Re: Retention of the *Eucalyptus tereticornis* (Forest Red Gum) located near the existing dam at 120-126 Hezlett Road, North Kellyville

Please find below a summary of my site visit on the 22/11/17 to 120-126 Hezlett Road, Kellyville (formerly known as 56-58 Hezlett Road) for the purpose of assessing the potential impacts from proposed construction, including the filling of the dam, on the nearby *Eucalyptus tereticornis* as part of the proposed development. I previously assessed this site on the 15/5/17 prior to the commencement of building design. This assessment is based on the impacts of the proposed landscape plan Revision K, dated 27/11/17.

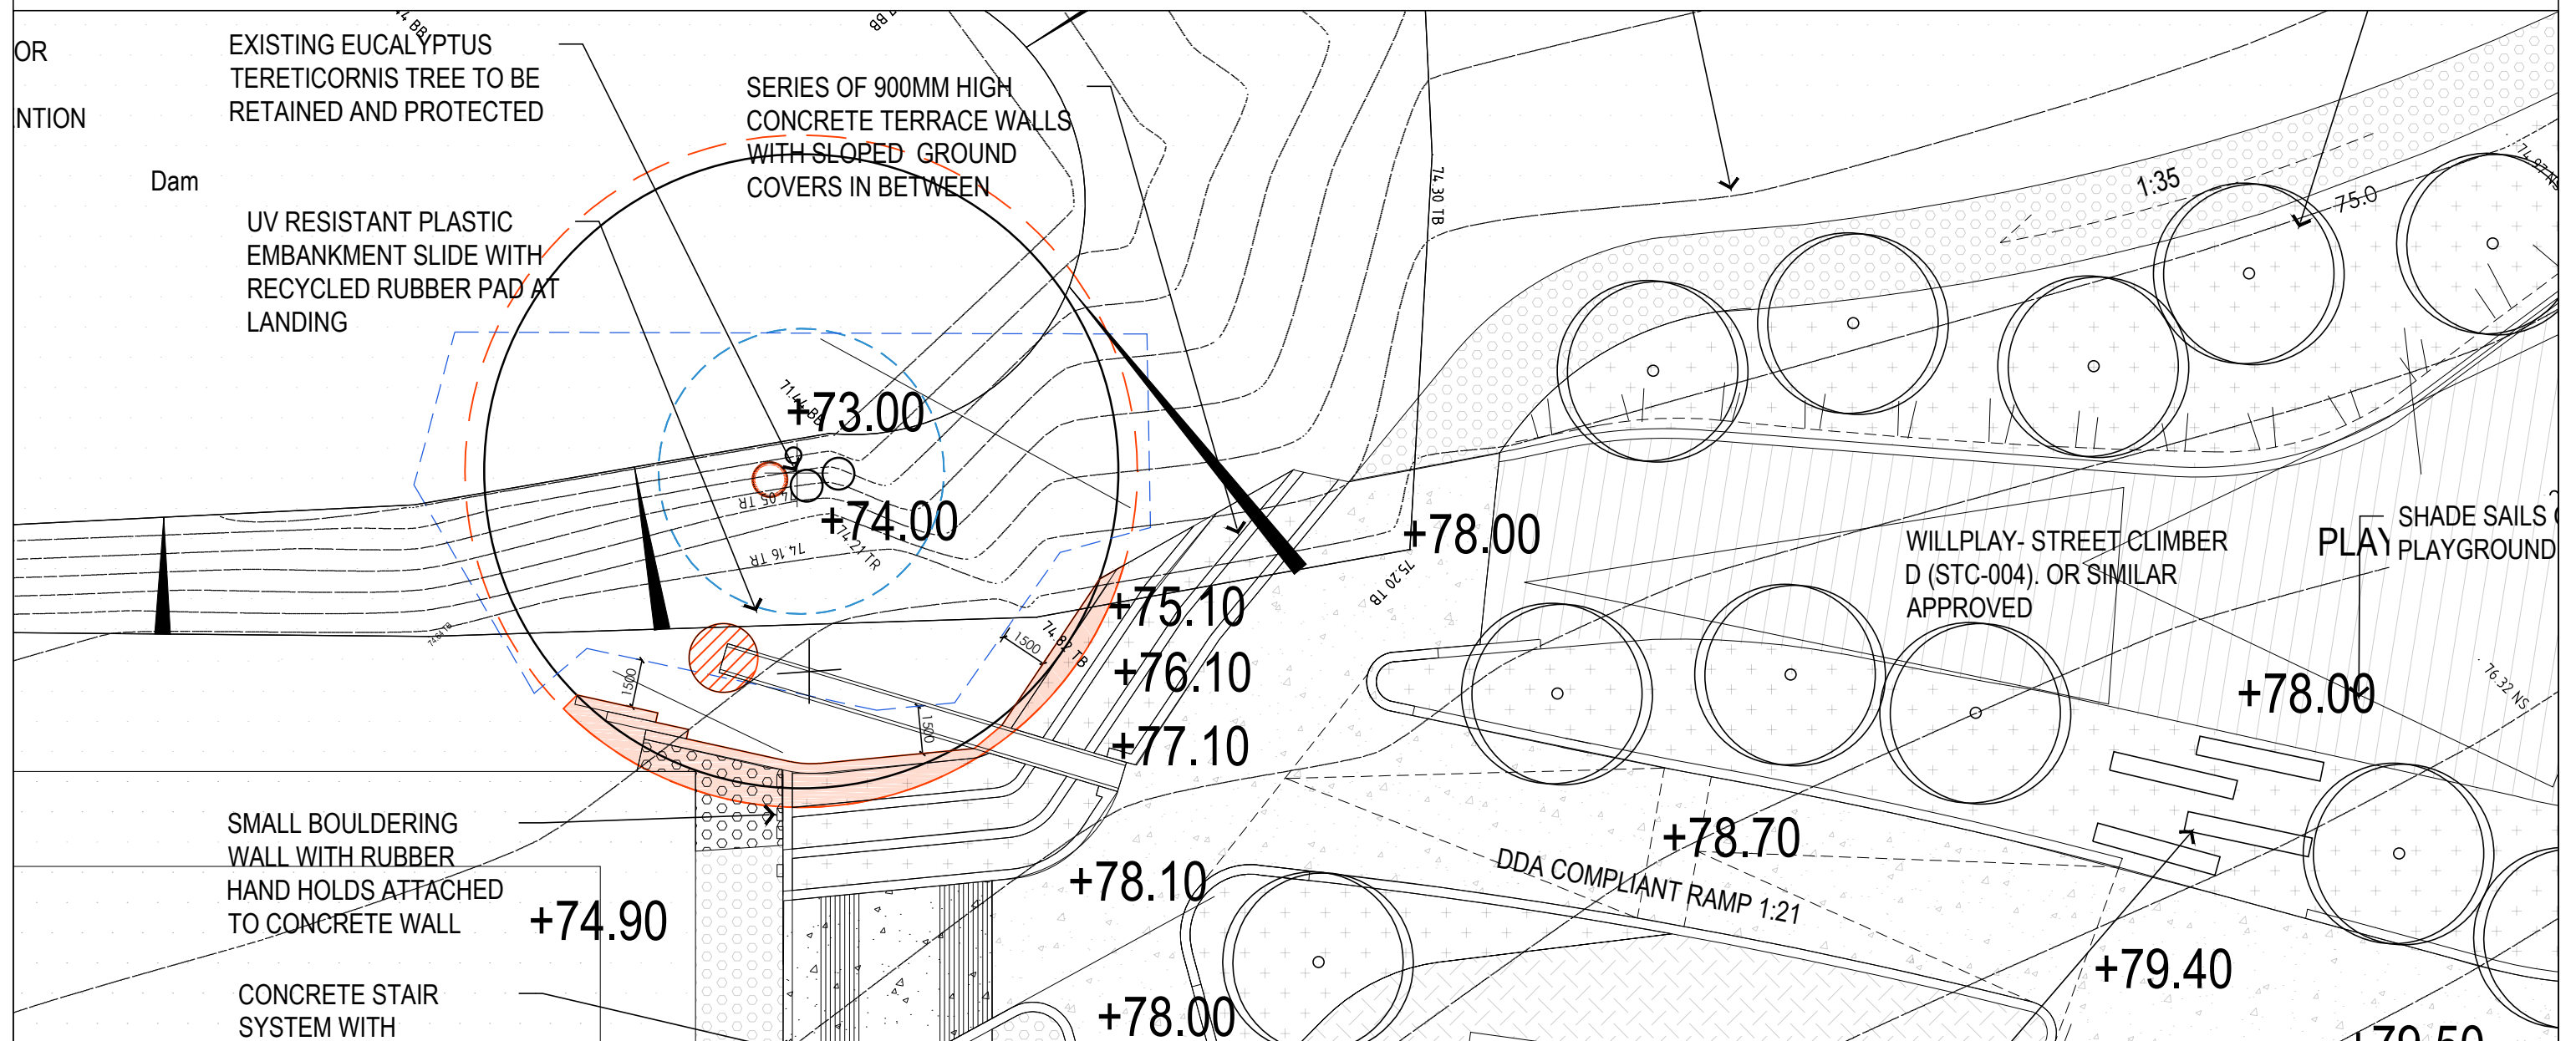
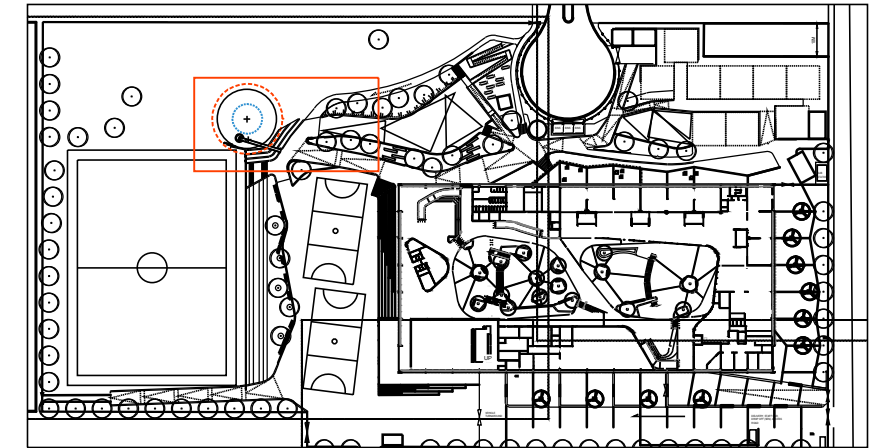
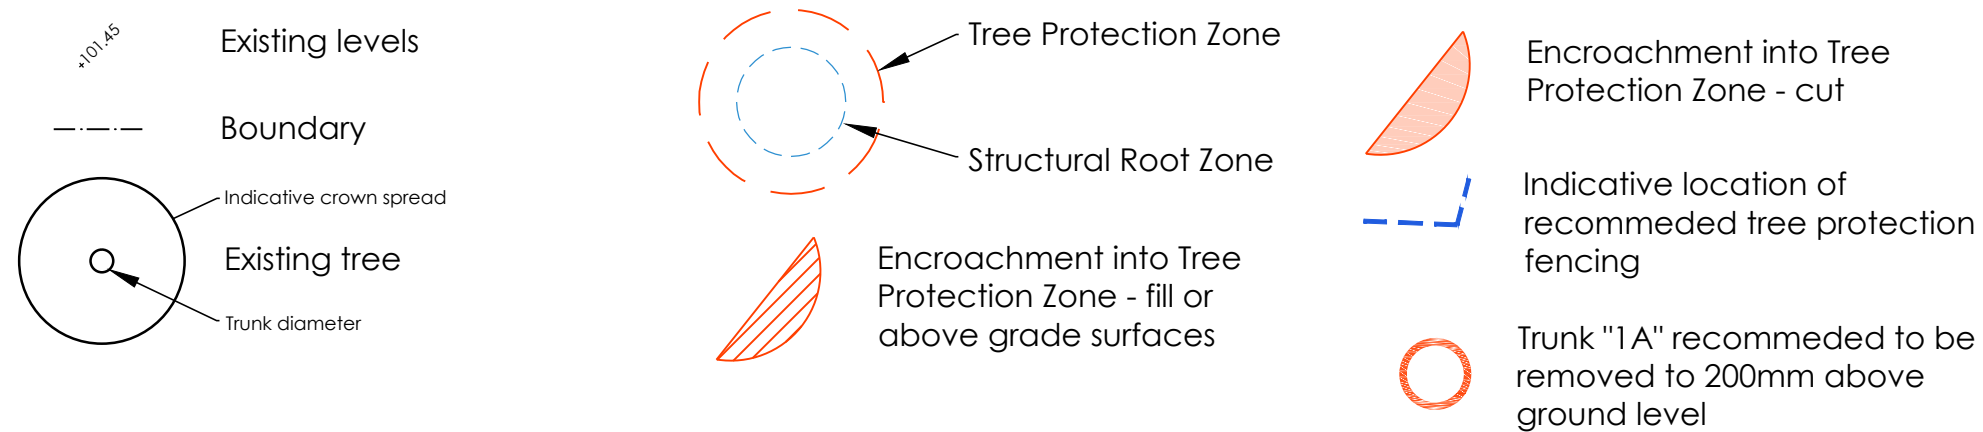
- Tree pruning of the tree trunk 'Tree 1A' and the lateral branch above the existing dam should be undertaken by a Level 3 Arborist. The final cut of 'Tree 1A' should be approximately 200mm above the existing ground level without stump grinding the root plate. Please refer to the images regarding pruning and the Tree Location Plan that indicates which trunk is to be removed.

- Tree protection fencing must be installed as per the Tree Location Plan. This area is to remain enclosed and isolated from all construction activities for the duration of the development, only to be temporarily reduced in area to allow the instalment of the plastic slide and landing pad. The fencing will partially enclose part of the dam once it has been filled to reduce compaction to this area in an effort to encourage future root growth. Once installed, the tree protection fencing is to be inspected by the project arborist prior to the commencement of construction.

Image 1 – Photo taken from north/dam side of tree, showing shale beneath the root buttress of the tree

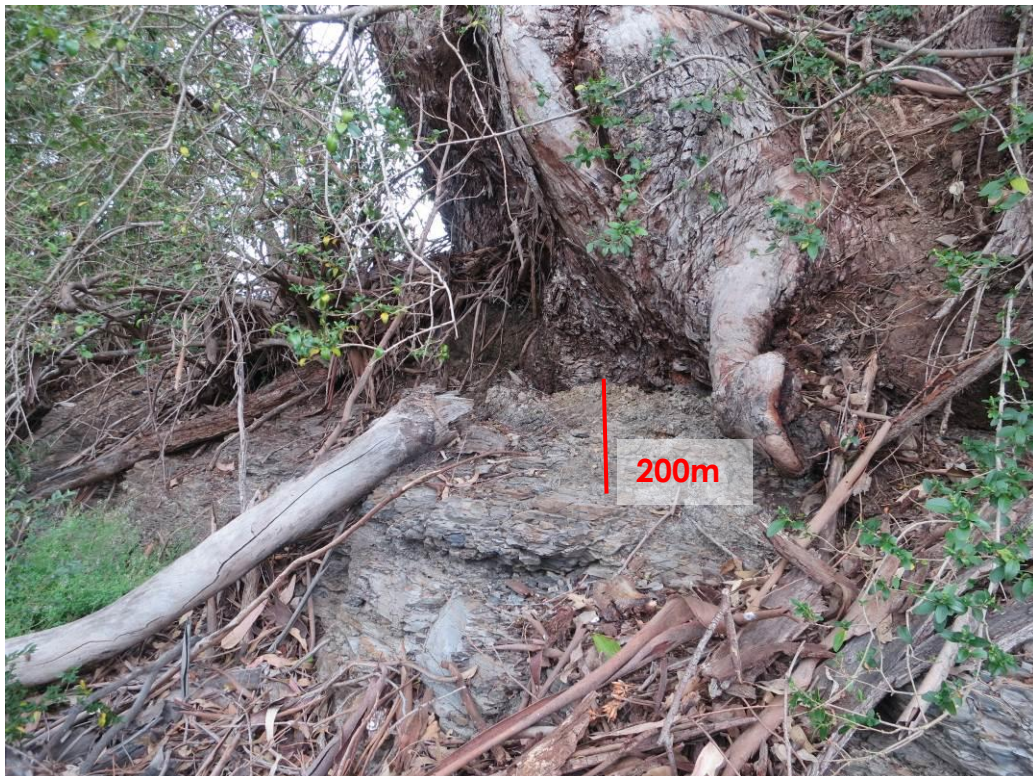
After close observation of the exposed soil profile on the side of the dam and beneath the existing root buttress of the interconnecting tree trunks, it is determined that the base of the root buttress is 200mm above shale bedrock (**Images 1 & 2**). Based on this observation, the majority of the root mass is likely to only inhabit the soil to the southern side of the tree (**Image 8**). Therefore, filling to the proposed RL of +73.00 as per the landscape plan will not contribute to tree impact from the development.
